NUM.	DATE	DESCRIPTION
B	04/25/25	ADDENDUM 3

Project: TOWN OF MONTGOMERY POLICE STATION
110 BRACKEN ROAD, MONTGOMERY,
NEW YORK 12549

Drawing: FIRST FLOOR PLAN - HVAC

H-101

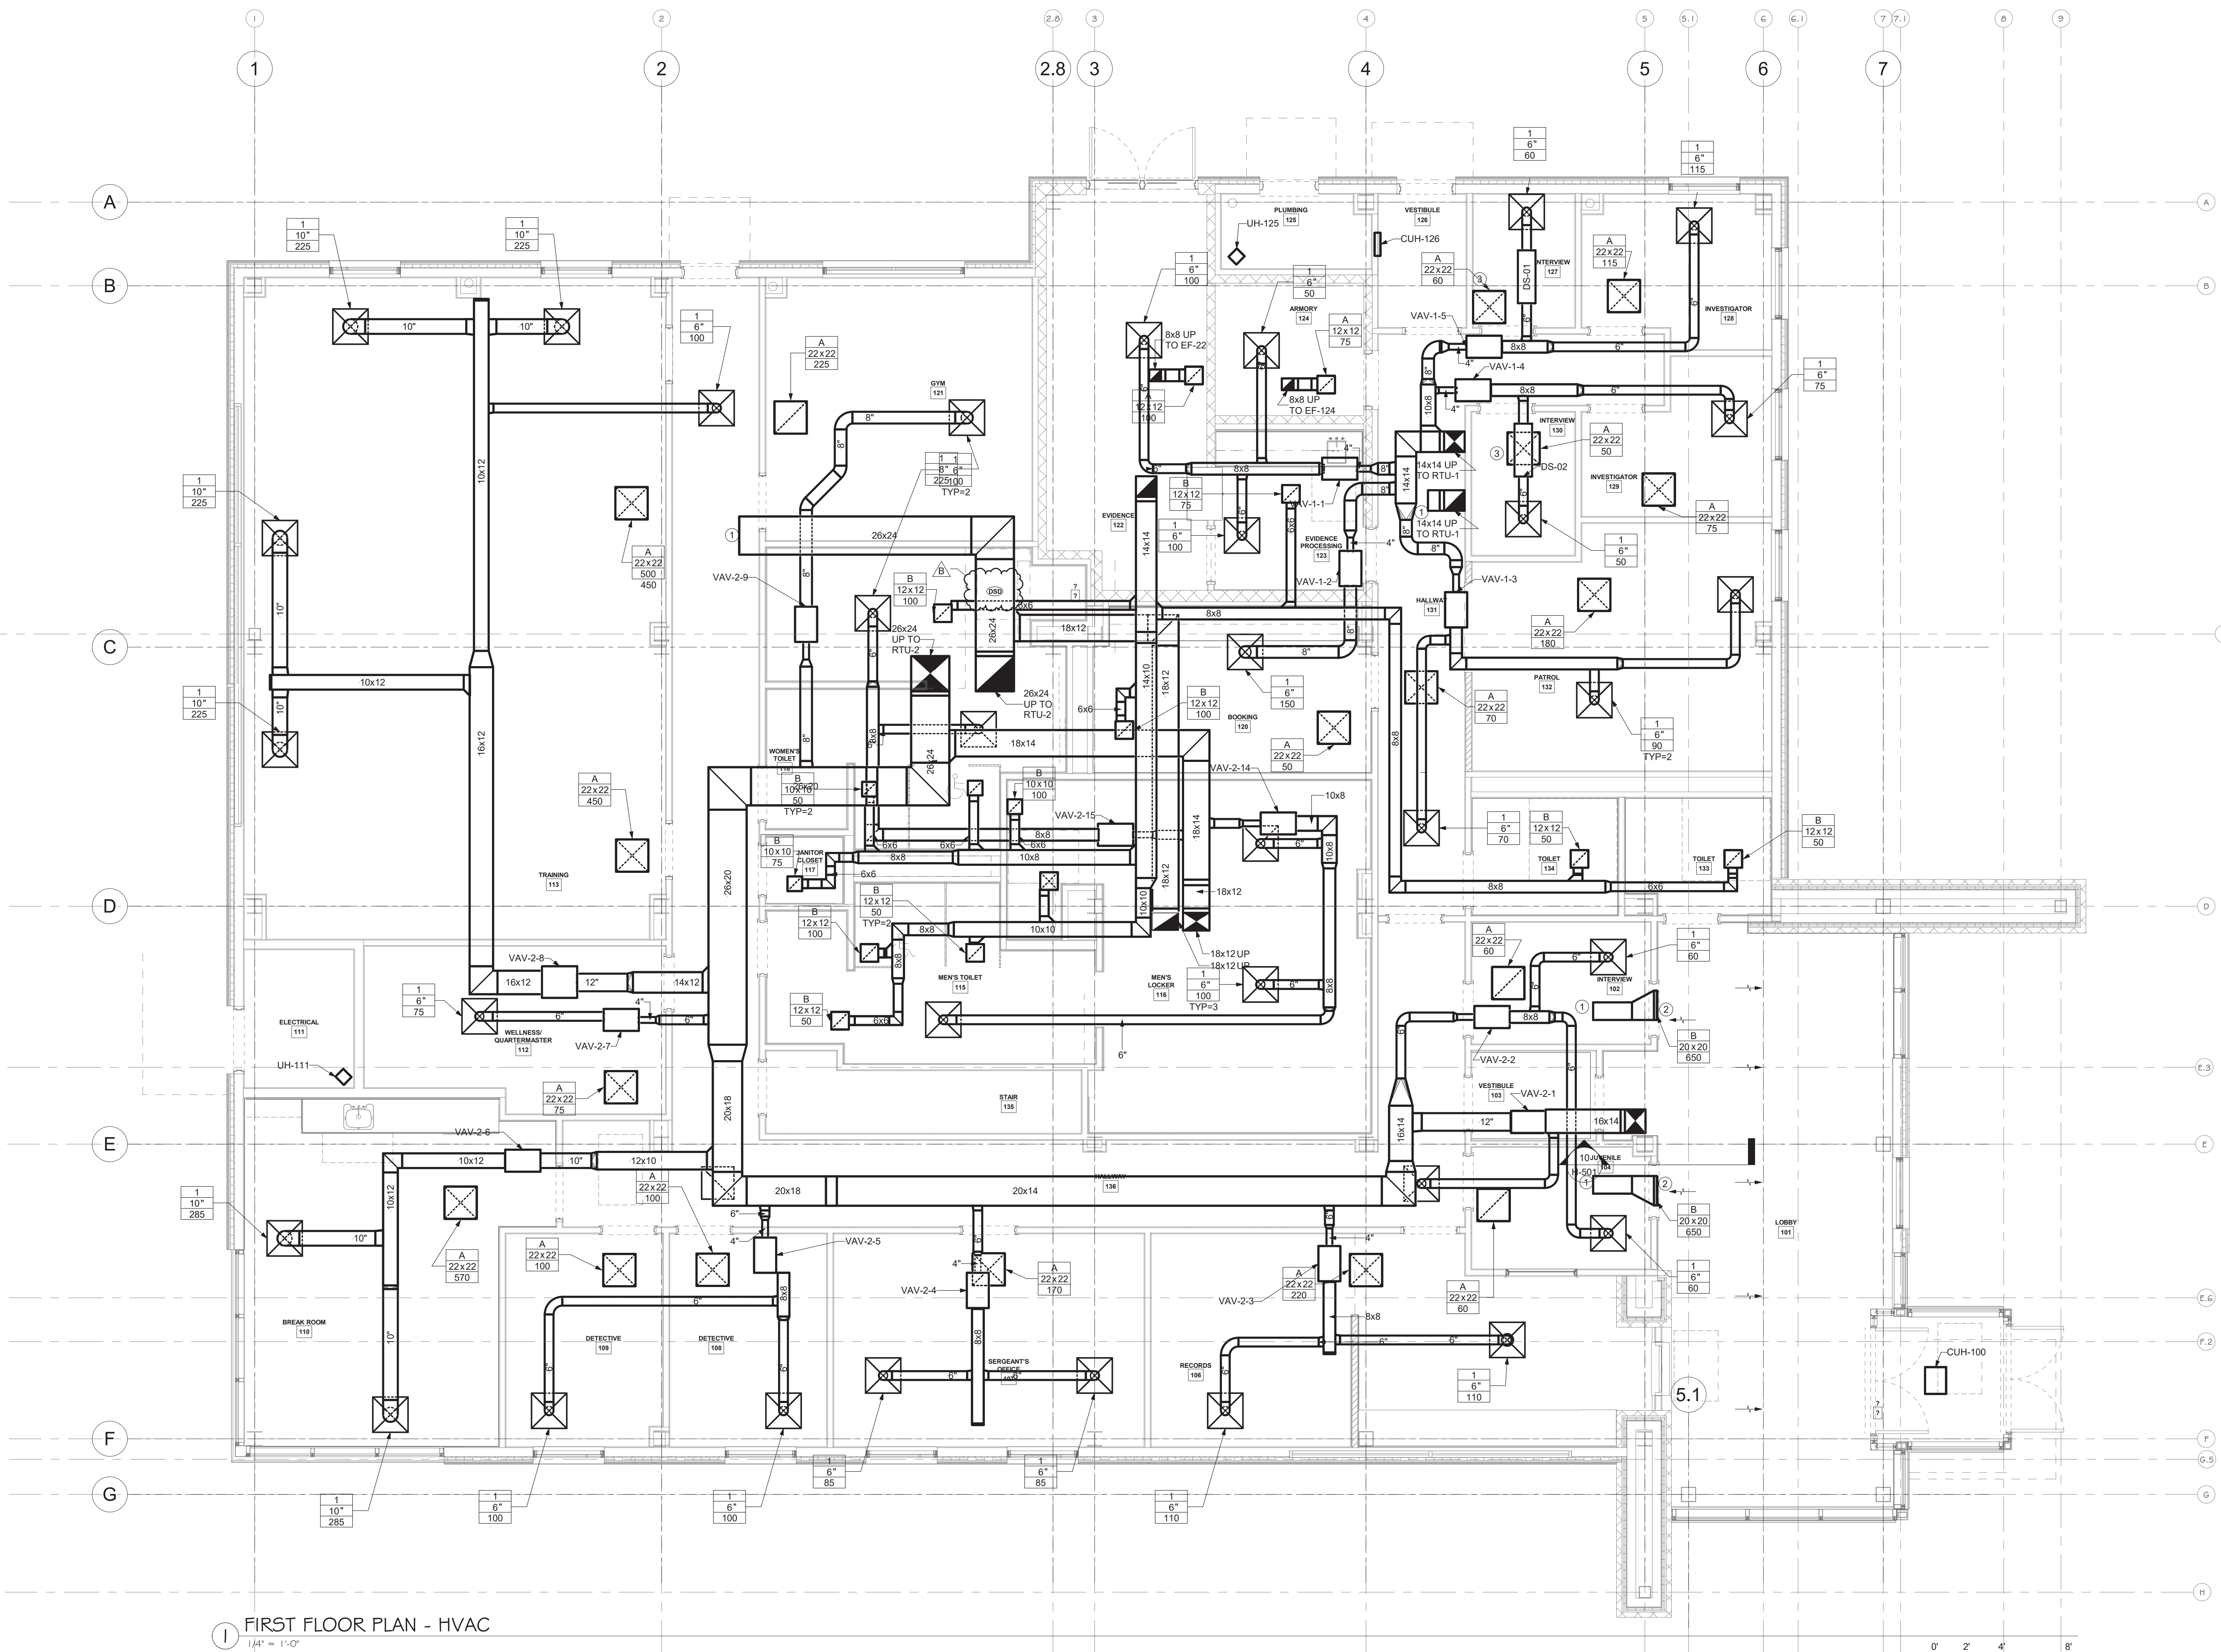
- 1 OPEN ENDED DUCT, CUT AT 45 DEGREE ANGLE.
- 2 RETURN GRILLE TO BE CENTERED ON DOOR FRAME, MOUNT AS HIGH AS POSSIBLE WHILE KEEPING ASSOCIATED DUCTWORK IN FIRST FLOOR CEILING SPACE.
- 3 PROVIDE PRICE RETURN AIR SILENCER (RAS) AT RETURN GRILLE. SIZE OF RAS TO MATCH RETURN GRILLE SIZE.
